HEIDENHAIN

Austauschanleitung
Replacing Instructions

EXE 837
EXE 937

10/2008

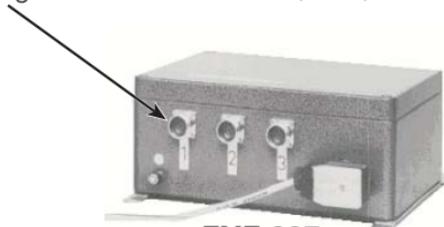
3. Messgerätekabel von der EXE 837 entfernen.
4. Ausgangskabel (Harting) entfernen.
5. Bei Bedarf eines zweiten TTL-Ausganges muss an die EXE 937 ein Anbaugehäuse (Harting, ID 284477-01) angebaut werden.

6. Messgerätekabel 1 an X2; 2 an X3; 3 an X1 der EXE 937 wieder anstecken.

7. Ausgangskabel wieder anstecken.
8. Die Verdrahtung an dem Hartingstecker des Ausgangskabels (kundenseitig) muss geändert werden.

Folgende Pins vertauschen:

B4 mit A6	A2 mit C4
A3 mit C5	C1 mit B5
C2 mit B6	B2 mit A4
B3 mit A5	A1 mit C3

3. Remove the encoder cables from EXE 837.
4. Remove the output cable (Harting).
5. If a second TTL output is required, an external mounting housing (Harting, ID 284477-01) must be mounted to EXE 937.

6. Reconnect the encoder cables to EXE 937: 1 to X2; 2 to X3; 3 to X1.

7. Reconnect the output cable.
8. The wiring of the Harting connector at the output cable (customer side) must be altered.

Interchange the pins:

B4 with A6	A2 with C4
A3 with C5	C1 with B5
C2 with B6	B2 with A4
B3 with A5	A1 with C3
